ADDENDUM NO. 01

September 23, 2026

**WARREN COUNTY CAREER CENTER
MEDICAL ACADEMY ADDITION
3525 NORTH STATE ROUTE 48
LEBANON, OHIO 45036**

LPA PROJECT NO. 263306.00

LIFE SAFETY PLAN

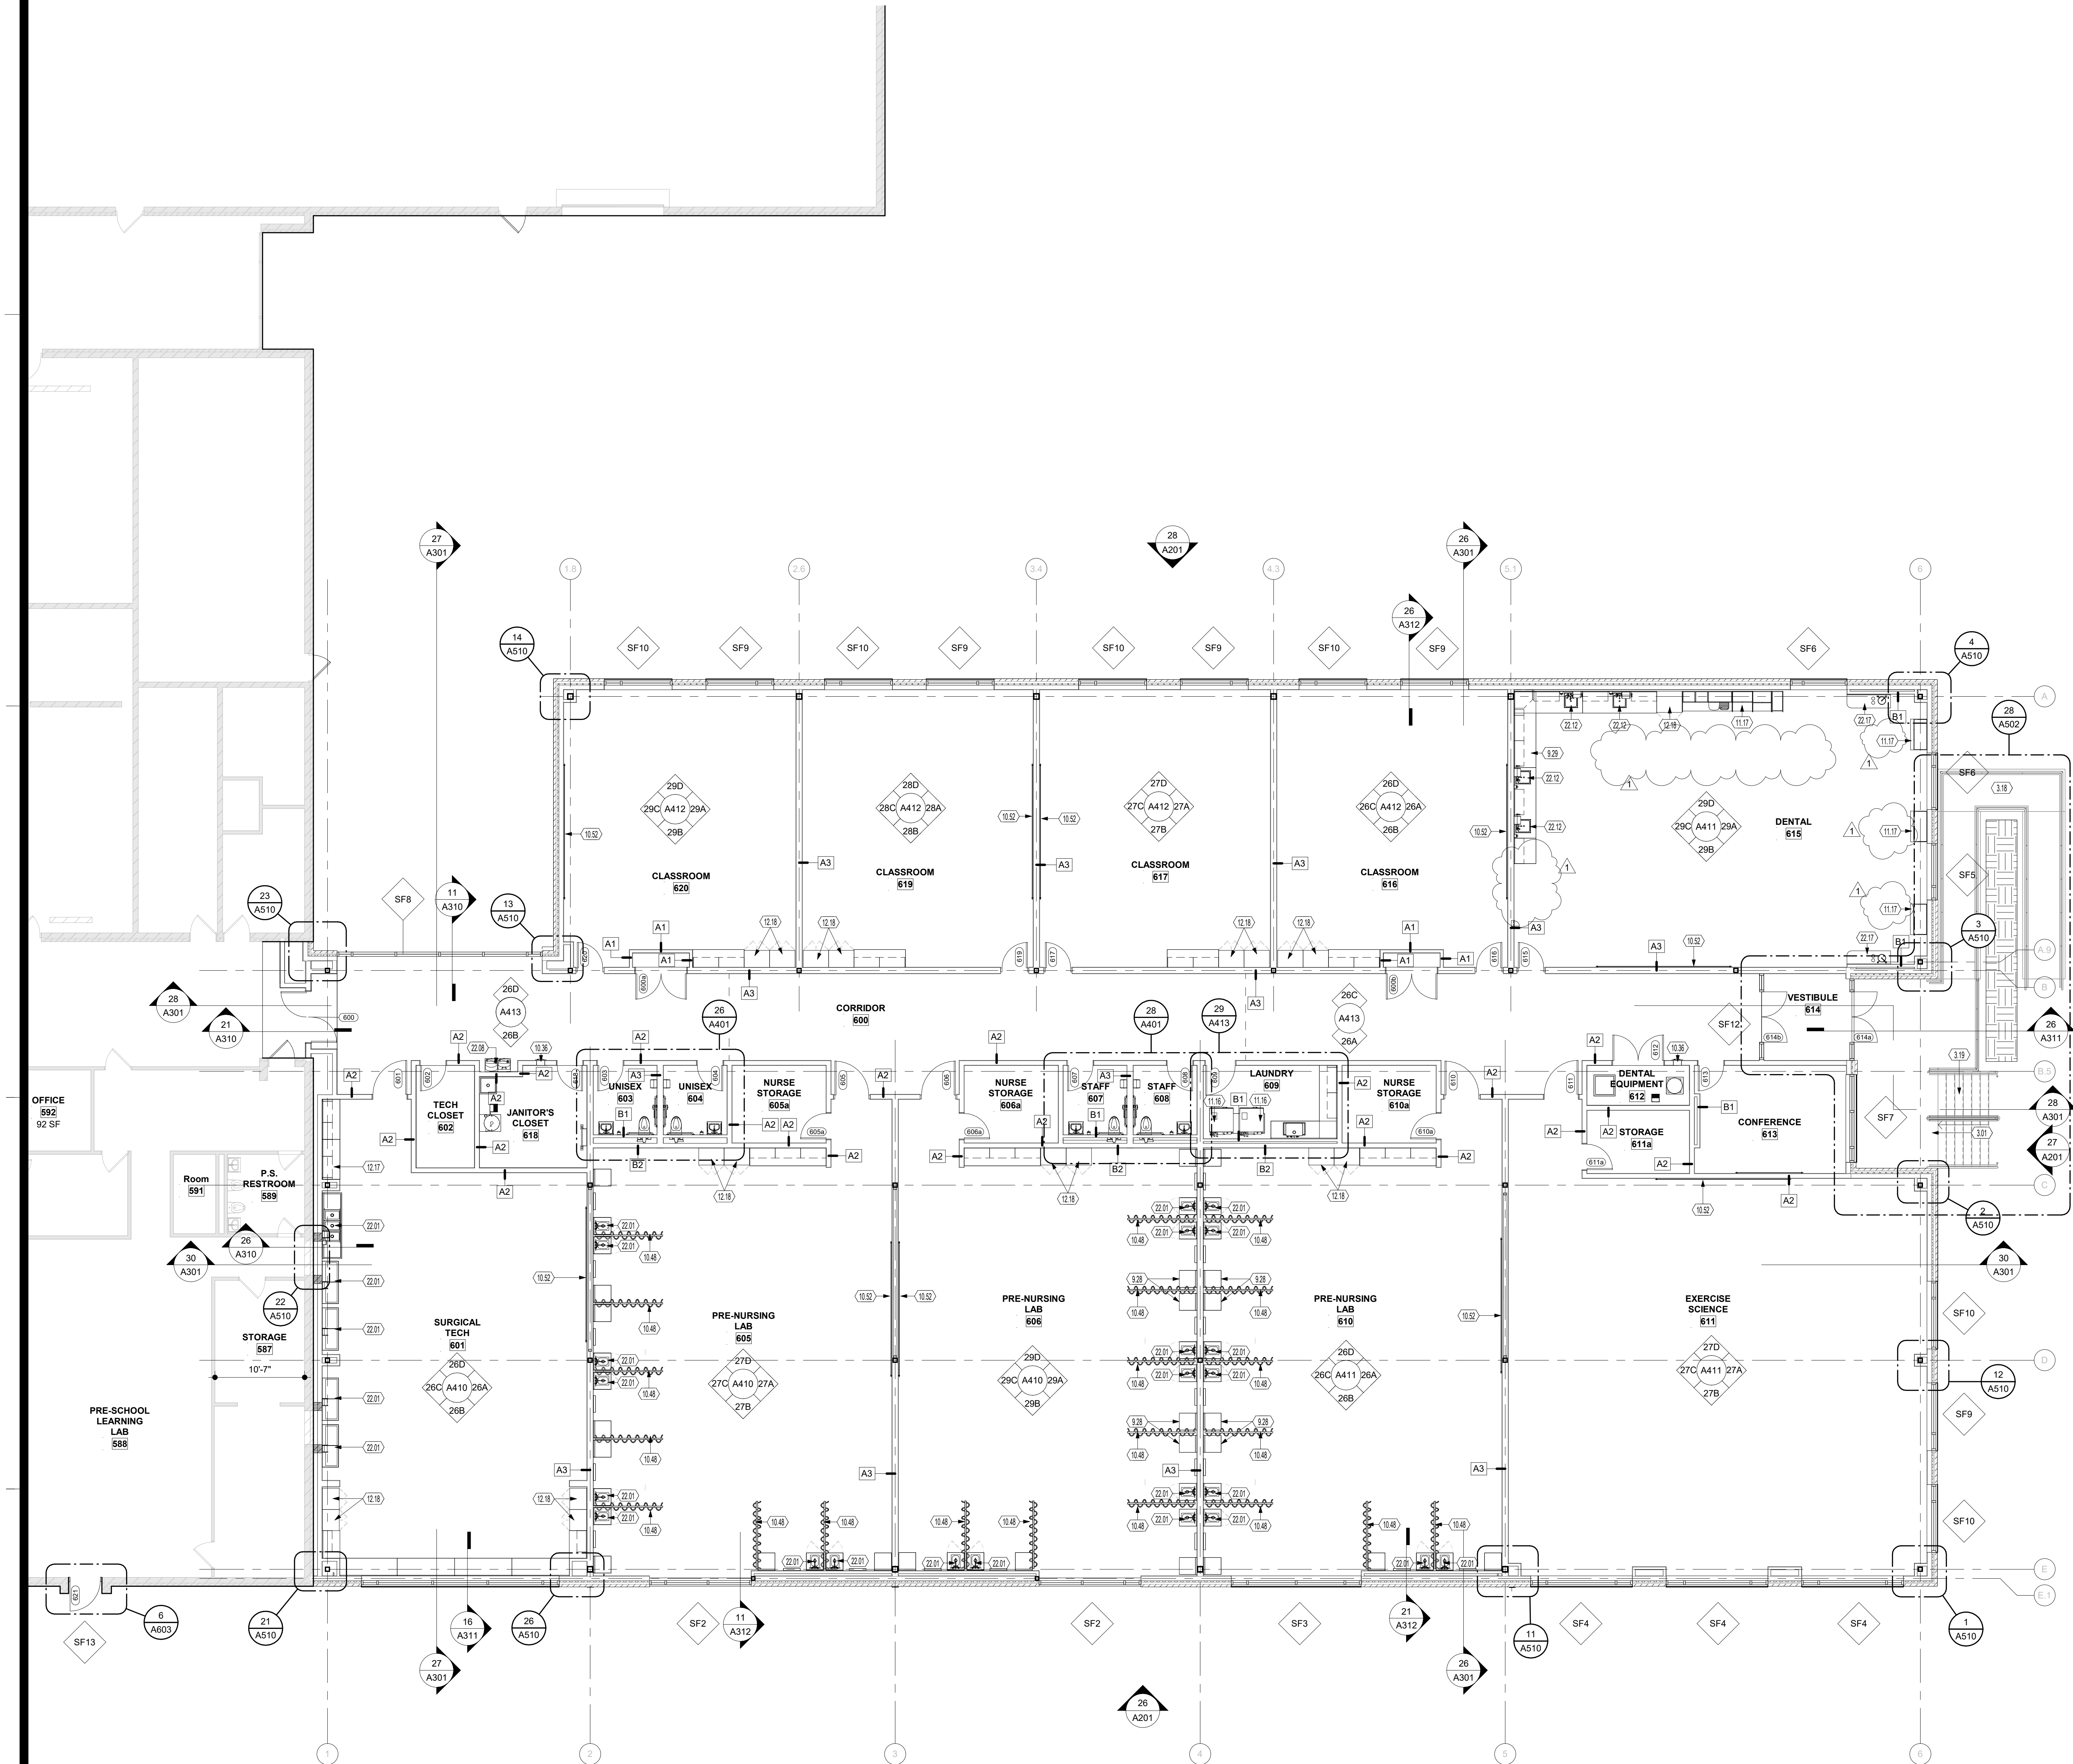
- 2.24 Sheet G004 Life Safety Plan
- Updated egress note regarding temporary barriers during construction.
- 2.25 Sheet L100 – Playground Plan
- Sheet Added to the Project

EXTERIOR
ELEVATIONS

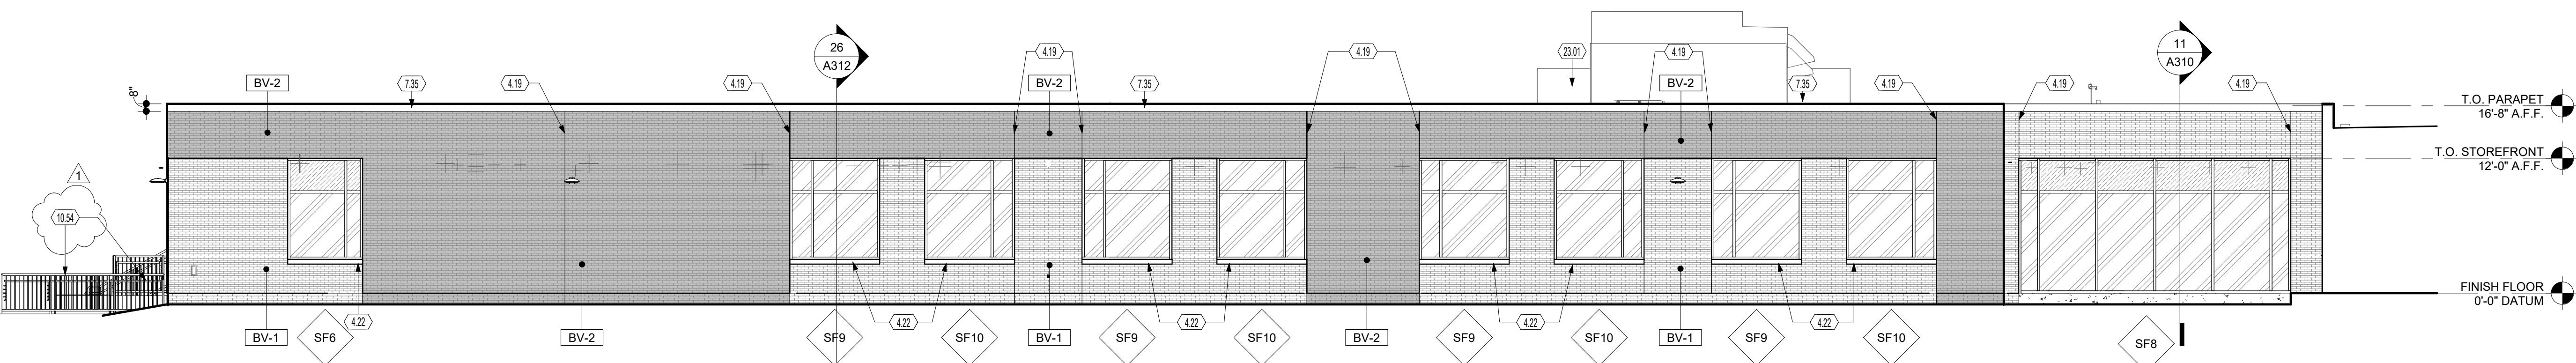
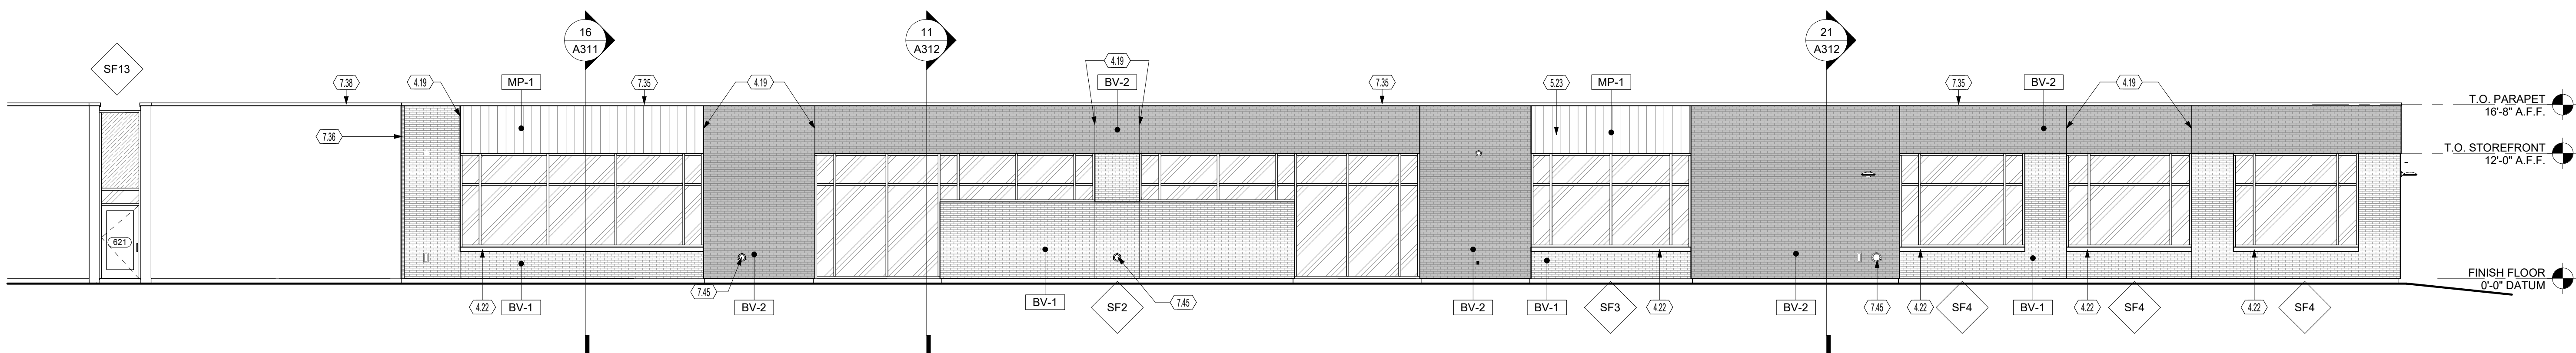
- Added door hardware set No. 11 to the drawings.
 - Updated quantities on Door hardware set 8
- 2.3 Reference: Sheet A201, EXTERIOR ELEVATIONS
 - Revised Keynote 10.54 to indicate Anodized aluminum handrail.

A411

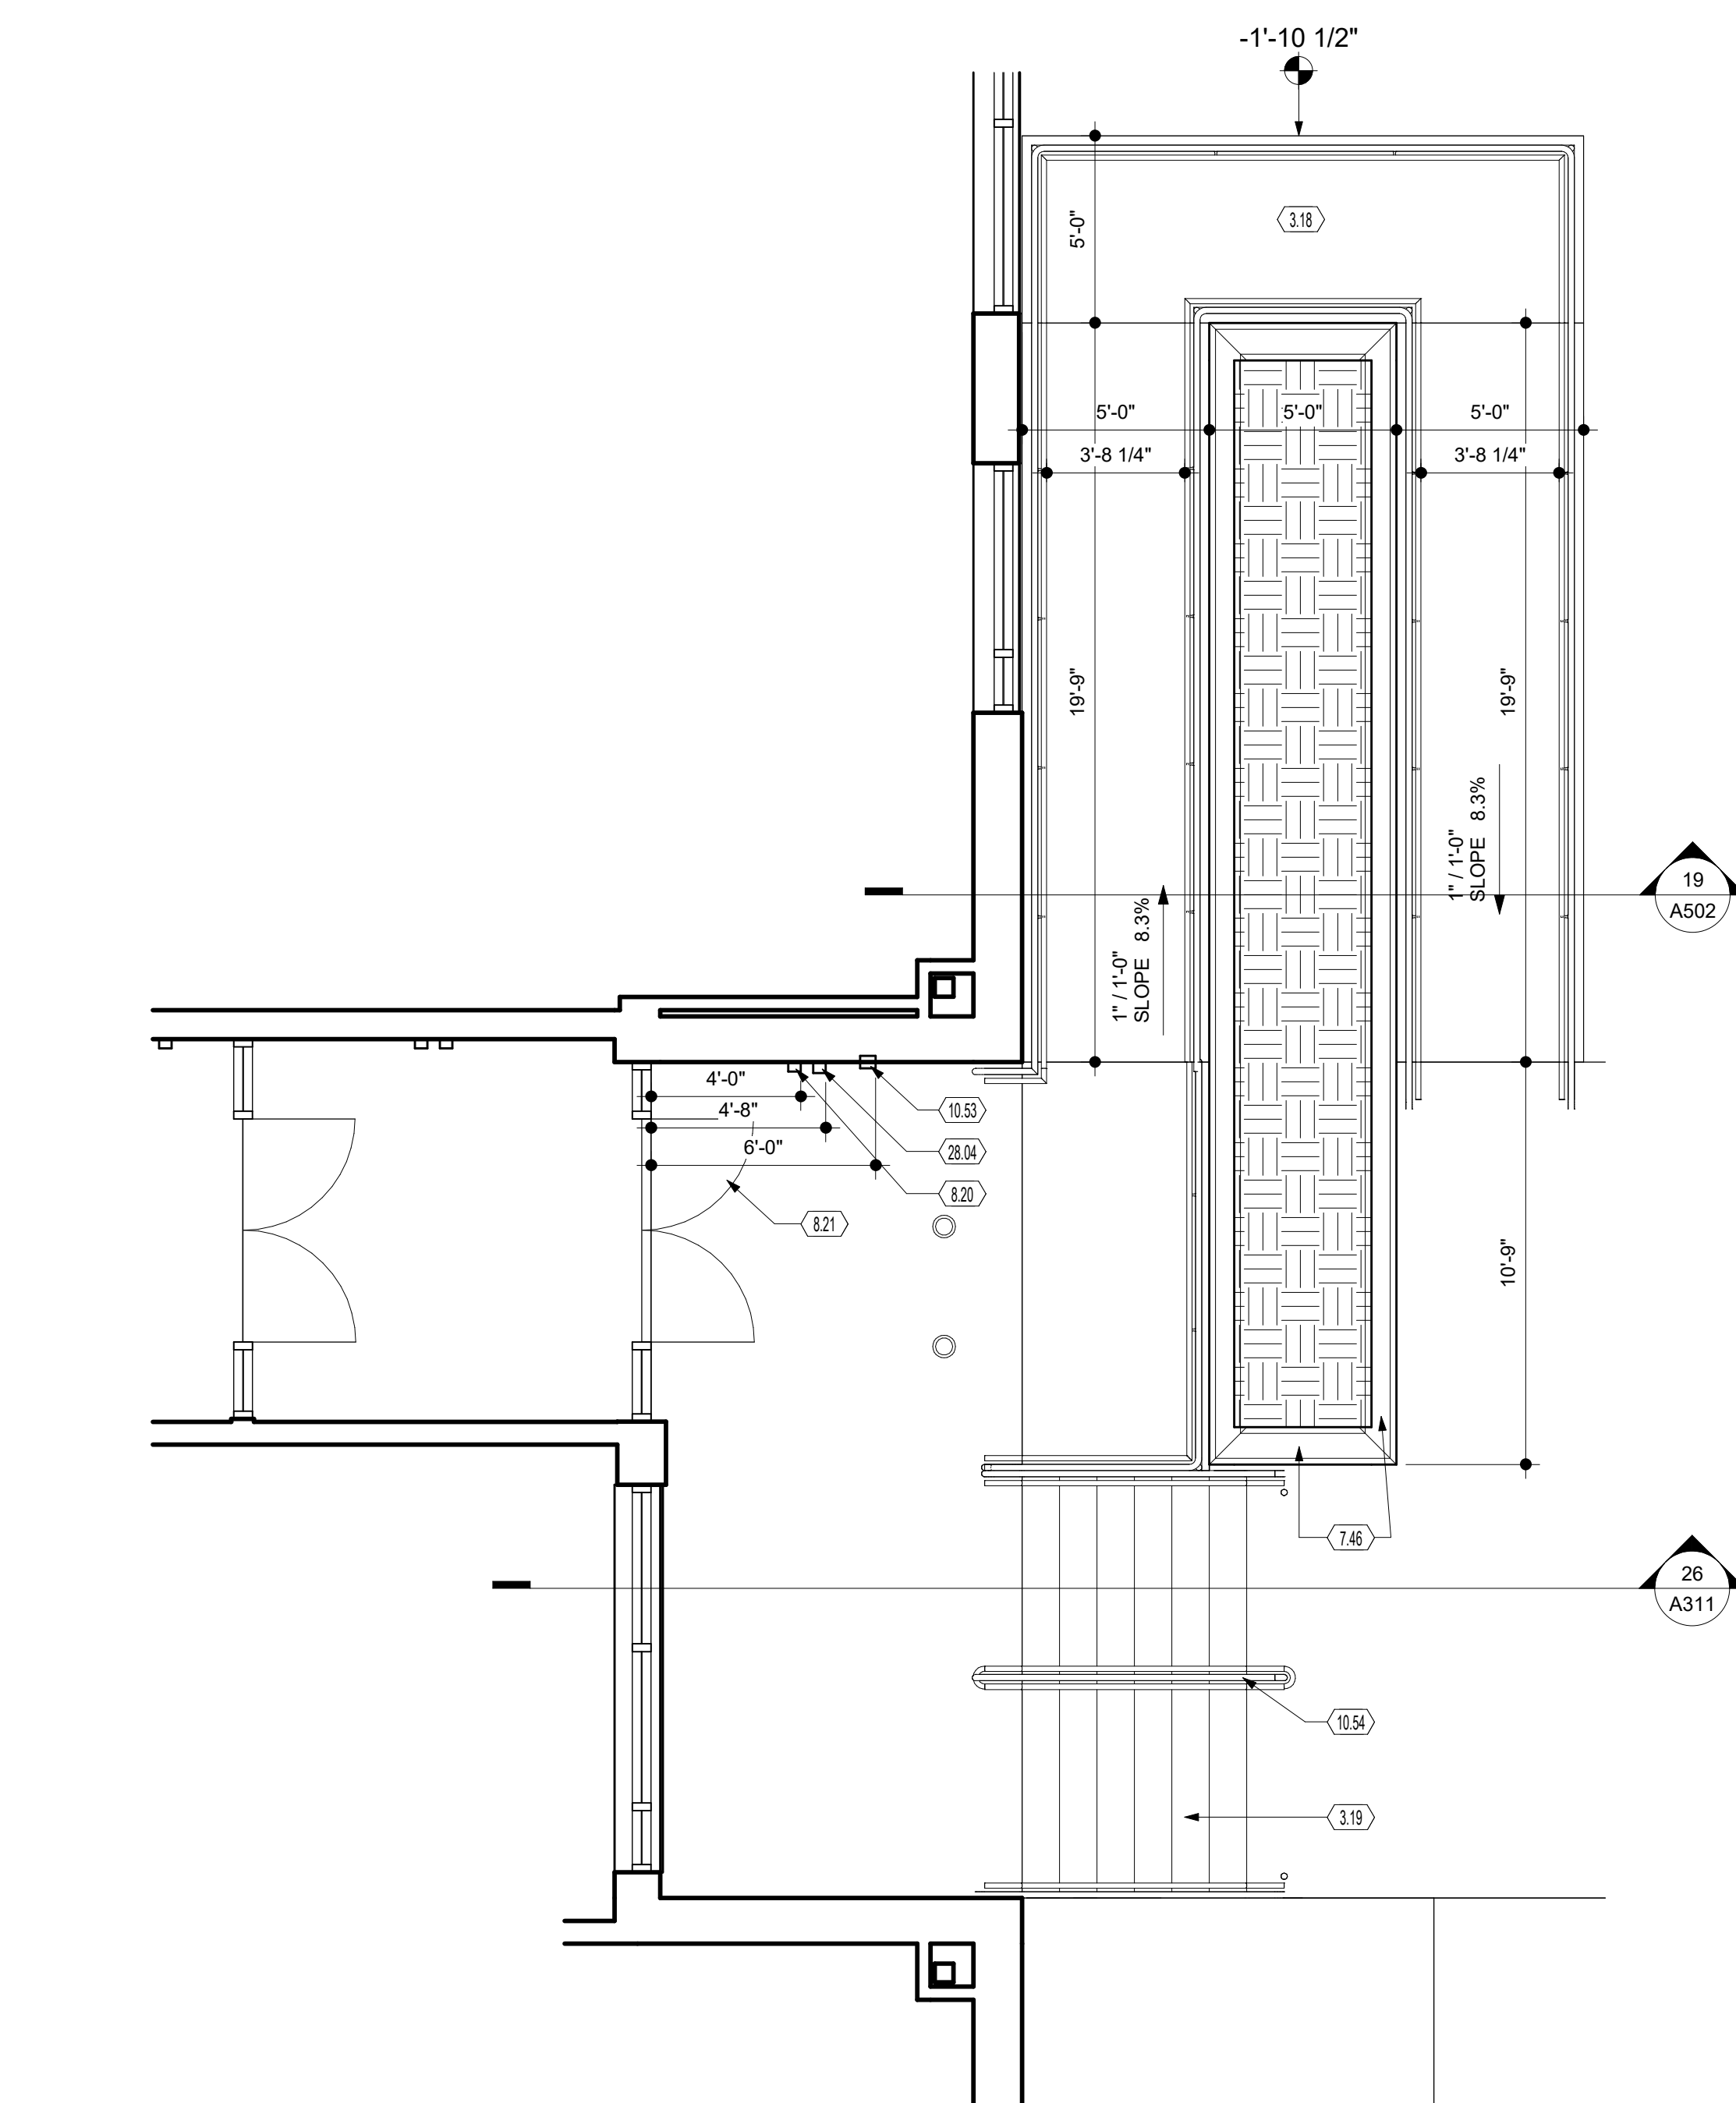
- 2.22 Sheet A411- Interior Elevations
- Updated interior elevation 29C to show the tall storage cabinets eliminated.
- 2.23 Sheet A141 Roof Plan
- Updated roof access ladder detail to be painted steel
